WATER RESOURCES IMPACT ASSESSMENT REVIEW
PROPOSED WASHINGTON LOOP FILL PIT
PUNTA GORDA, FLORIDA
FEBRUARY 2, 2009

Ms. Barbara Jefferies
Charlotte County
Land Development / Building Construction Services
18400 Murdock Circle
Port Charlotte, FL 33948

The H2H Associates, LLC Specialized Geological Modeling Group (H2H) was contracted by Charlotte County to review a permit application submitted by the Triple D Investment Group L.L.C. for the proposed Washington Loop Fill Pit (Pit) that included a water budget analysis prepared by Johnson Engineering (JE); comment on the completeness of their assessment of potential impacts on groundwater and nearby water bodies; and recommend a consistent methodology for the development of groundwater resource impact assessments from which Charlotte County can review this and similar proposals in the future.

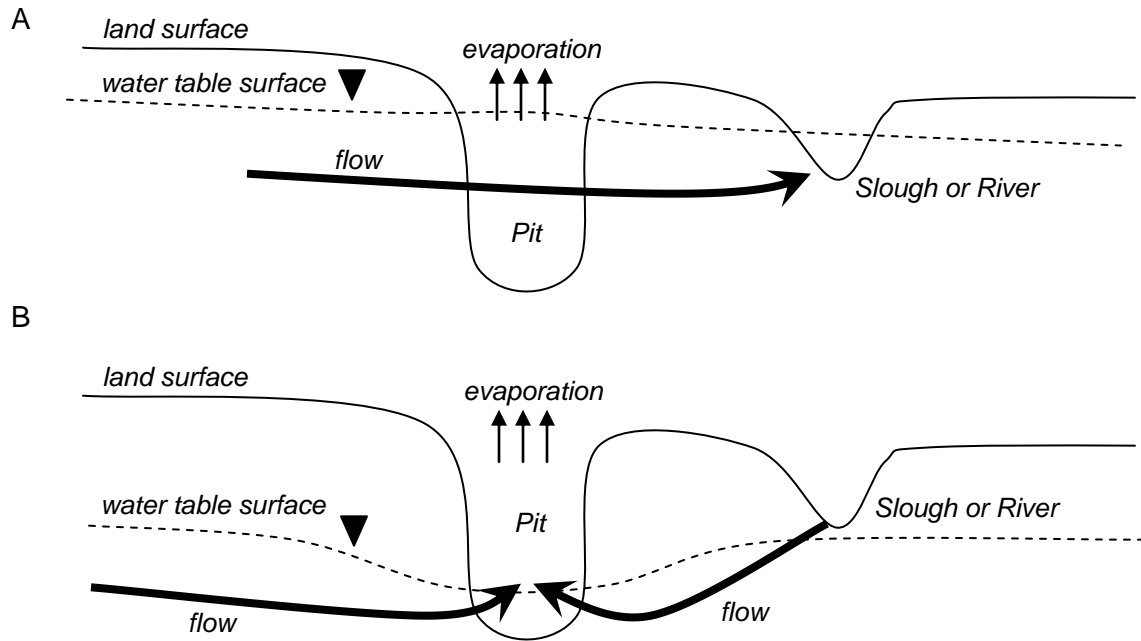
Focusing on drought conditions therefore indicates a greater than three-fold larger impact on flows into the water bodies than was estimated for the average conditions. Moreover, the Pit can become a groundwater sink during drought conditions if water table elevations fall below the elevations of Myrtle Slough and/or the channel of Shell Creek. This is because the proposed elevation of the bottom of the Pit (~ -31.52 ft) is well below those elevations. The Pit will therefore remain flooded and subject to evaporation even when water table elevations fall below Myrtle Slough and Shell Creek. Under these conditions, the water bodies will lose water to the surficial aquifer and local flow will be directed to the Pit due to extractions by evaporation.

Hypothetical water table configurations associated with average and drought conditions are shown in Figure 1. The best way to constrain probable water table configurations due to variations in rainfall, evaporation, and the Pit configuration, and the resulting potential impacts on flows in the water bodies and groundwater levels beneath the wetlands is through the development and use of a groundwater flow model. Benefits of and requirements for such a model will be discussed later in this report.

Figure 2. Aerial map showing the location of the proposed Pit relative to the recommended locations of groundwater model boundaries and required data points.

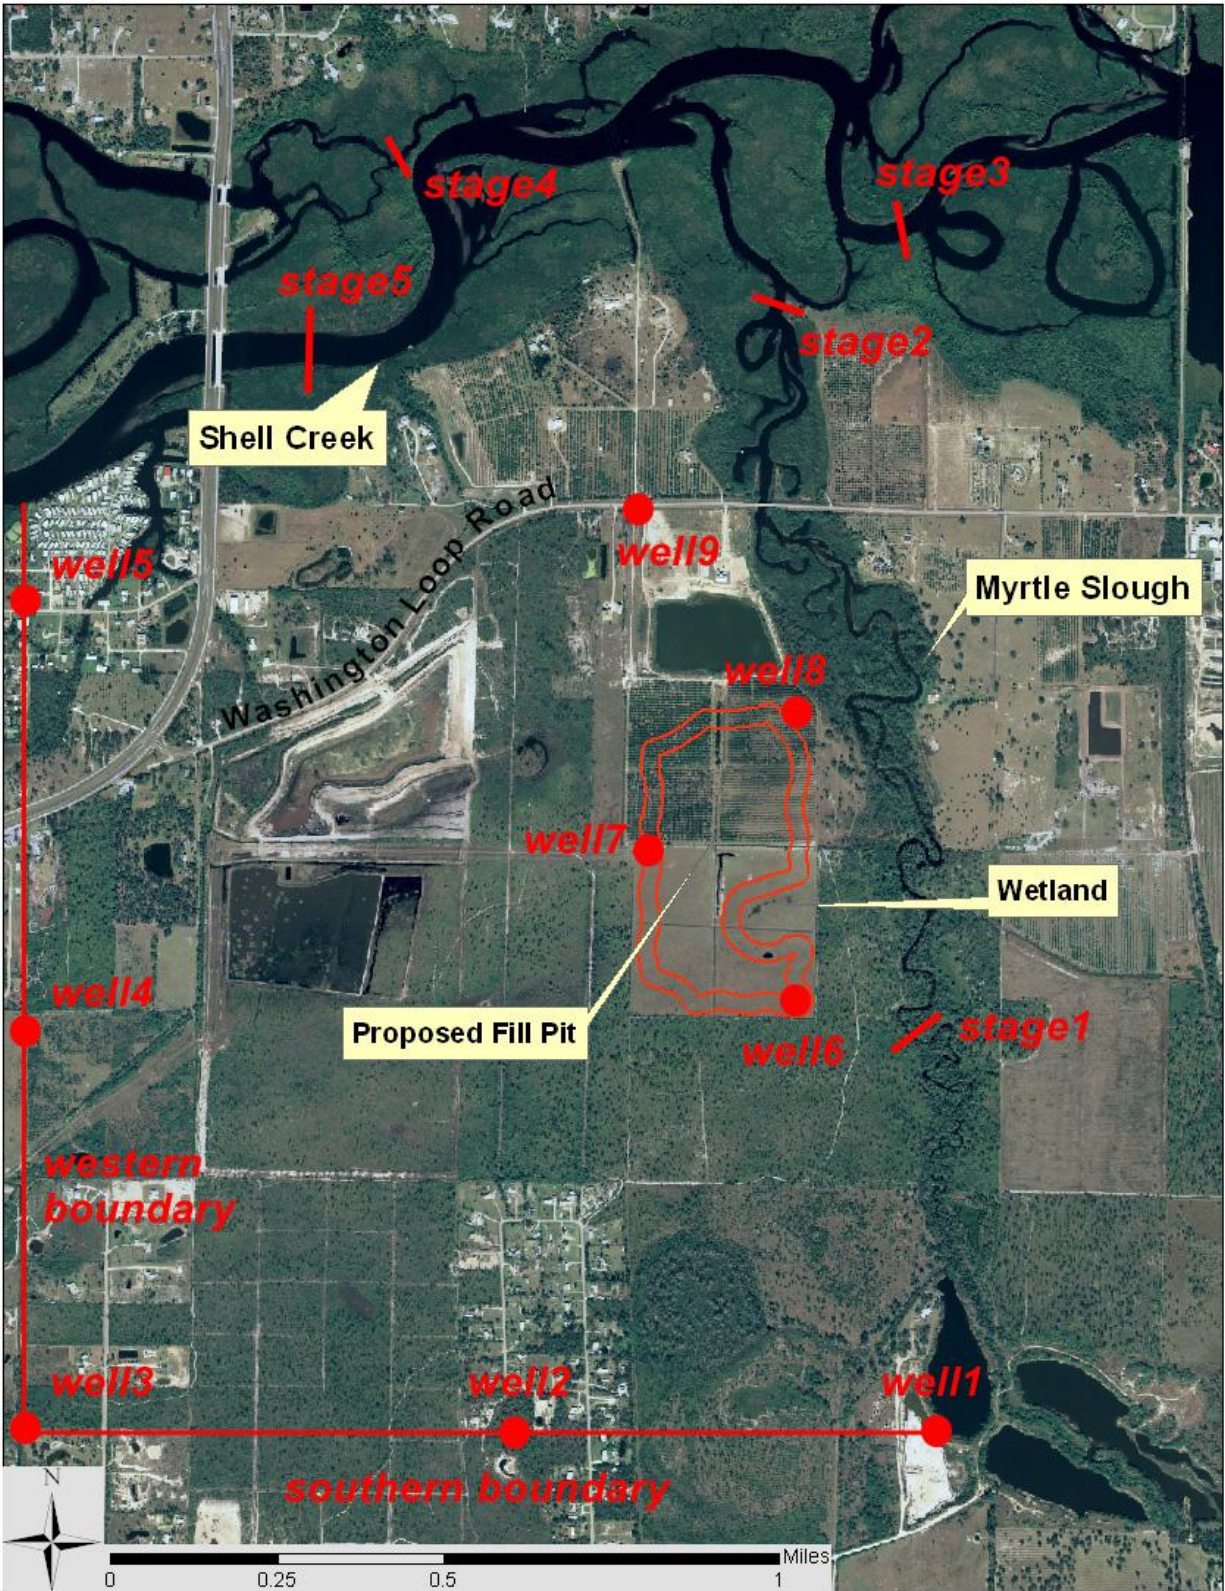
The model boundaries should include the natural hydrologic divides created by Shell Creek to the north and Myrtle Slough to the east, an arbitrary east-west line well to the south of the proposed Pit, and a north-south line well to the west of the proposed Pit roughly perpendicular to Shell Creek. Constant head boundary conditions should be assigned to both creeks and the arbitrary southern boundary. No-flow conditions should be assigned to the north-south line to

the west. Figure 2 shows a box surrounding the general area that should be addressed in a well-constructed groundwater model.

- stream stage data for Shell Creek and Myrtle Slough;
- minimum of three wells along the southern model boundary from which groundwater levels can be measured; and
- minimum of two additional wells along the western model boundary from which groundwater levels can be measured.

Stream stage and flow measurements should be obtained for the Slough and Creek from two locations in Myrtle Slough and three locations in Shell Creek allowing for a quantification of flow gains or losses in each creek across the modeled region. Data collections from the wells and stream stage/flow stations should be performed over as short a time period as possible to ensure that all measured values are reflective of the same hydrologic condition. The combined dataset should be obtained at least twice, once during average/high water level conditions, and once during low water level conditions. Figure 2 depicts a distribution of boundaries and site wells, and stage and flow measurements that would fulfill the data requirements.
